PRODUCT SAFETY WARNING AND RECALL NOTICE

REMINGTON MODEL 887™ SHOTGUN RECALL

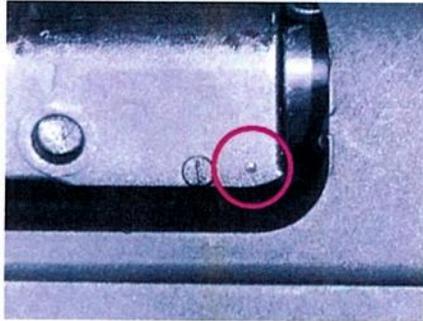
VERIFICATION OF CORRECTIVE ACTION: Upon repair of your shotgun, you will note a punch mark on the bolt (see photo below). This mark confirms your shotgun has been inspected and repaired by Remington under the recall program.

Remington has also corrected the manufacturing process to eliminate this potential firing pin problem in shotguns manufactured after November 24, 2014. Shotguns manufactured after November 24, 2014 will also have a punch mark on the bolt.
